IREDELL COUNTY HEALTH DEPARTMENT

IMPROVEMENT PERMIT / AUTHORIZATION TO CONSTRUCT / OPERATION PERMIT / EXISTING SYSTEM INSPECTION

PERMIT# 19263 PIN# 4669111796.012 DATE 7-16-07

SUBDIVISION Bethany Place BLOCK / SECTION _____ LOT 12 LOT AREA 1.27 Acre SITE CLASS P&S DESIGN FLOW 480 L.T.A.R. .30

INITIAL SITE SKETCH

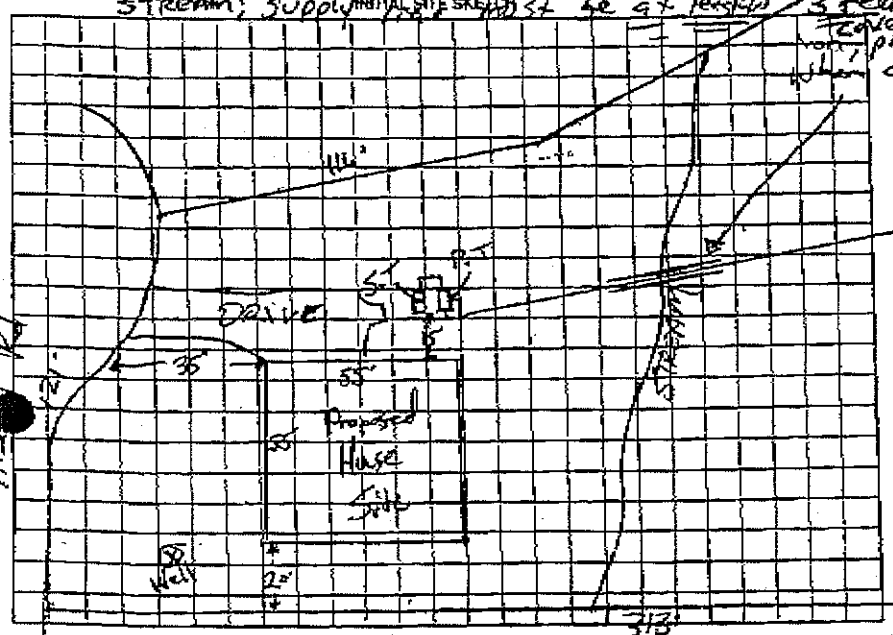
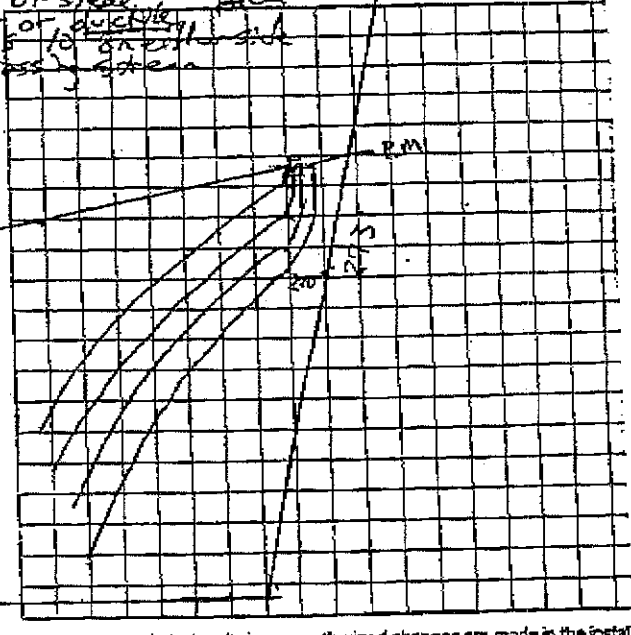
Comments/Conditions: 1) Keep Drain Lines at least 10' from property lines & supply lines/Pressure manifold at least 5'
2) Tanks must be 15' or more from side of basement wall
3) Drain Lines & Tanks MUST BE 50' from STREAM; Supply lines must be at least 25' 3 feet of stable cover or ductile pipe to cross stream
